Service-Information Motorcycle

©BMW of N.A. Service Department	Group: 61 General Electrics	August, 1992 61 027 92 (2548)	For USA Only
------------------------------------	--------------------------------------	-------------------------------------	--------------

Additional Ground Between Engine and Frame - R100R Models

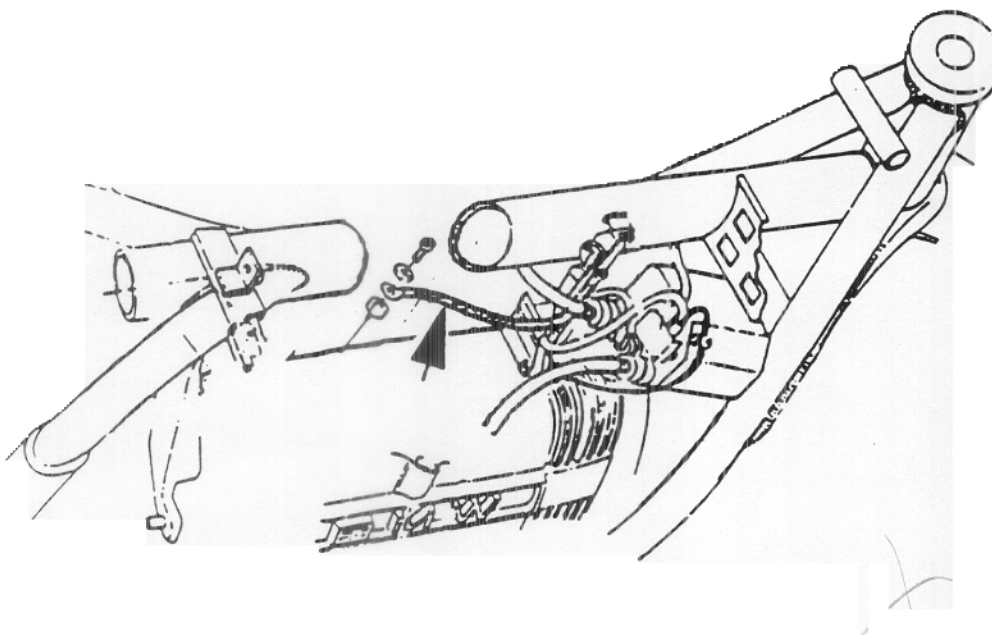
Problem: Grounding between the engine and frame is not always reliable on silver-painted frames. This may lead to ignition misfiring or insufficient alternator output.

Line Change: Starting with VIN 0280227, a wire has been added from the starter motor cover to the ignition control unit mounting bracket.

Remedy: Install a ground wire to all affected R100R models with a VIN prior to 0280227.

The ground wire is secured to the left starter motor cover screw and the ignition control unit mounting bracket.
